Subject: NRC Request for Additional Information (TAC No. MD3410)
dated July 1, 2008.

Attachment 2 Requalification Program for the NBSR

Attachment 3 Technical Specification for the NIST Test Reactor (NBSR)

**Technical Specifications
for the
NIST Test Reactor (NBSR)**

Figure 6.1

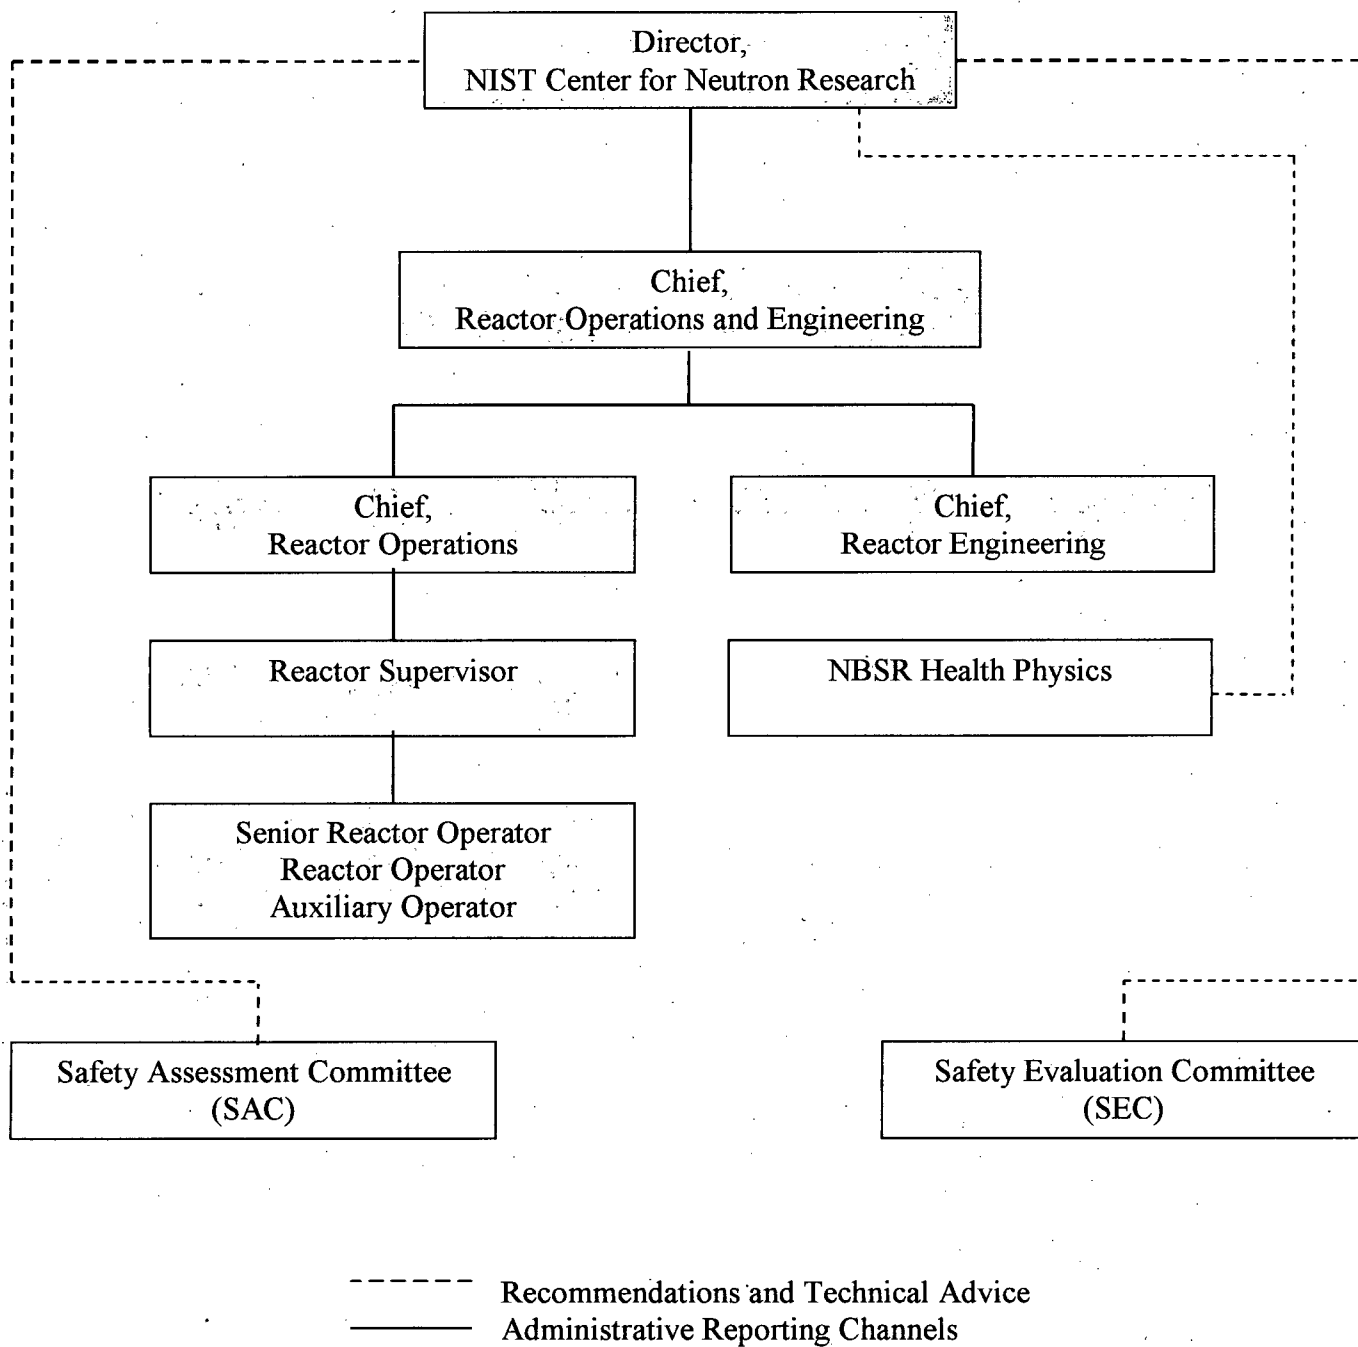
4. TS figure 6.1: The legend will be revised to correct a typographical error.

TS figure 6.1 legend has been revised (see attached copy).
